Addendum # 1

Laboratory and Little Drive Trail Improvements Research Triangle Foundation August 14, 2026

PROJECT: **LABORATORY DRIVE & LITTLE DRIVE TRAIL IMPROVEMENTS**

SHEET NUMBER: 2A-1

DETAIL 1 - TIMBER RAILING

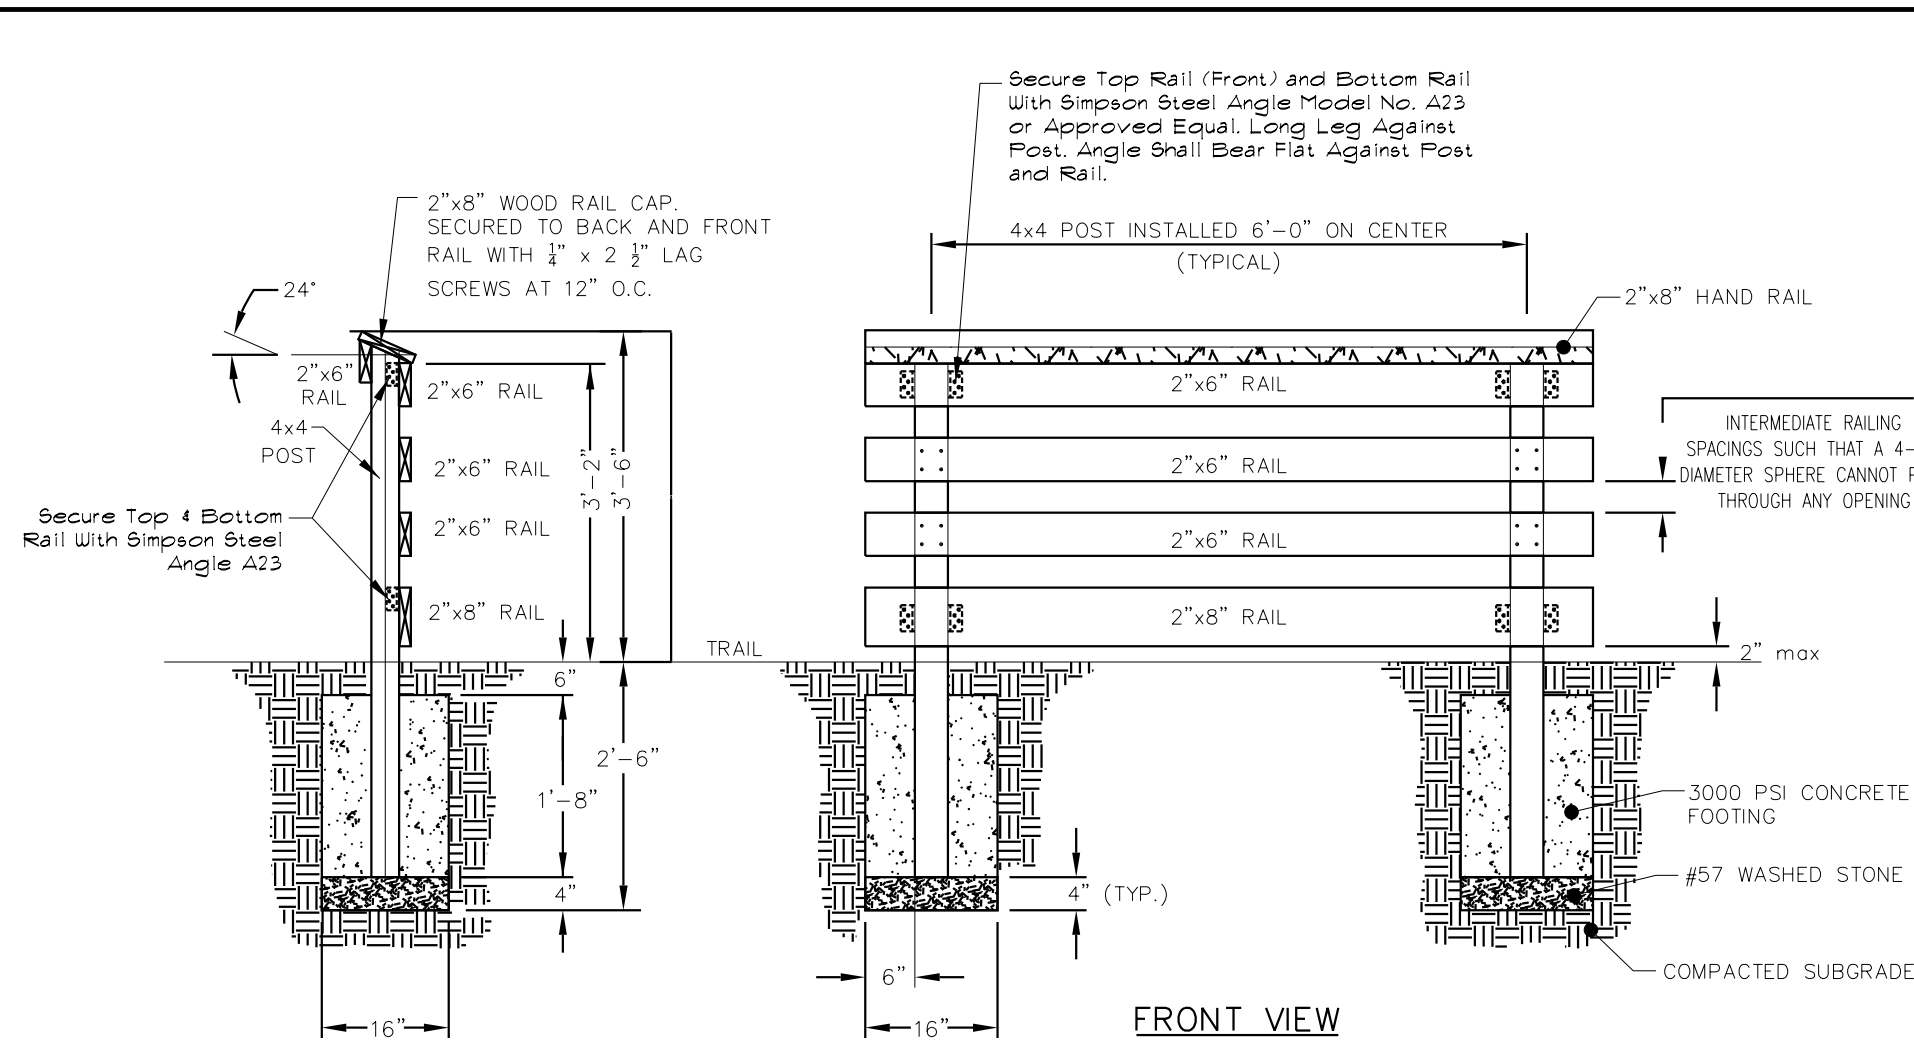
After investigating the current condition of the wooden railings on Laboratory Drive, and discussing further with Research Triangle Foundation, the existing Timber railings from stations -G2- Sta. 14+42 to 14+72 (LT & RT) and from -G2- Sta. 35+74 to 36+16 (LT) should be removed and replaced as part of this project.

Updated plan sheets with the timber railing details, and an updated bid proposal form have been attached to this addendum. A specification for replacement of this railing is listed below.

This item consists of removal of the existing timber railing and installation of a new proposed timber railing where indicated in the plans or as directed by the Engineer. The timber railing shall be in accordance with the details provided in the plans.

1. All timber shall be No2 grade southern yellow pine treated to 0.6 ACQ. All finished edges to be rounded over.
2. Stain with one coat of TWP California Cedar.
3. All bolt holes thru timber shall be predrilled 1/16" larger than the bolt diameter.
4. Posts shall run full height and no splicing is allowed.
5. All railings shall be continuous over two supports and connected to 4x4 posts with (2) 1/4" x 2 1/2" lag screws. Stagger discontinuity points with rail above and below.
6. Field preservative chemicals shall be applied to all field cuts and drilled holes to maintain timber pressure treatment integrity.
7. Railing with ware of 3/8" or more may be grounds for rejection, removal and replacement.
8. All hardware shall be hot dip galvanized or stainless steel.
9. Top rail shall be attached to front and back rail with 1/4" x 2 1/2" lag screws @ 12" o.c.
